Access Compliance Report

Public Rights-of-Way

Intersection ID: 2576	Main Street: CAMBRIDGE_BAY_DR	Cross Street: WHISTLER'S_CHASE_DR	Location: N
ADA ID: FE6239ED0B6F	Ramp Type: PerpDiag	Initial Pass/Fail: Fail	Overall Compliance: No
Severity Score: 33.75			
Codes/Mitigation Info/Possible Solution		Field Measurements/Component Compliance

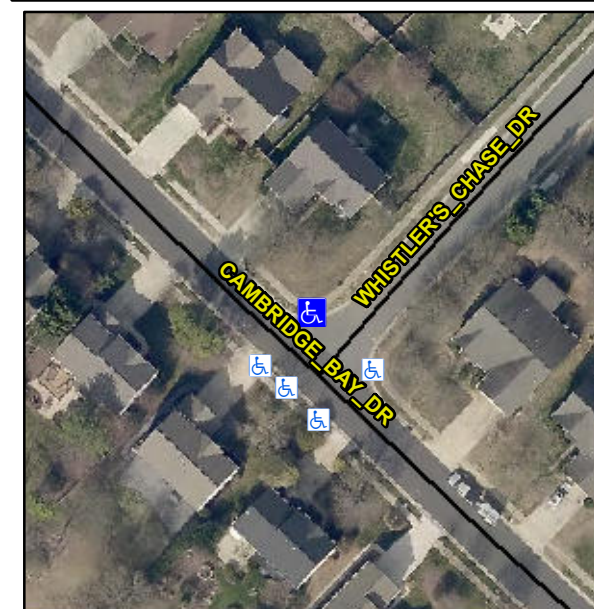
Not Found, R304.5.1, R304.2.2, R304.5.3

Compliance	Description	Data	Compliance	Description	Data
N/A	Ramp Length (in)	43.0	No	Ramp Slope (%)	10.4
No	Ramp Width (in)	37.0	No	Ramp XSlope (%)	6.6
N/A	Flare Type LT	N/A	N/A	Flare Type RT	N/A
N/A	Flare Slope LT (%)	N/A	N/A	Flare Slope RT (%)	N/A
N/A	Flare Traversable LT?	N/A	N/A	Flare Traversable RT?	N/A
N/A	Landing Length (in)	N/A	N/A	DWS Provided?	N/A
N/A	Landing Width (in)	N/A	N/A	DWS Contrast?	N/A
N/A	Landing Slope (%)	N/A	N/A	DWS Length (in)	N/A
N/A	Landing X Slope (%)	N/A	N/A	DWS Full Width?	N/A
N/A	Landing Curb? (Y/N)	N/A	N/A	DWS Offset (in)	N/A
N/A	Shared Landing?	N/A			
N/A	Gutter Ponding?	N/A	N/A	Gutter Slope (%)	N/A
N/A	Gutter Lip Ht (in)	N/A	N/A	Gutter X Slope (%)	N/A
N/A	Painted X Walk1?	No	N/A	Painted X Walk2?	No
	X Walk 1 Direction	To SW		X Walk 2 Direction	To SE
N/A	X Walk 1 Width (in)	N/A	N/A	X Walk 2 Width (in)	N/A
	X Walk 1 Slope (%)	4.8		X Walk 2 Slope (%)	3.6
	X Walk 1 X Slope (%)	3.2		X Walk 2 X Slope (%)	4.9

Remove & Replace Curb Ramp With Two New Directional Ramps or Equivalent.
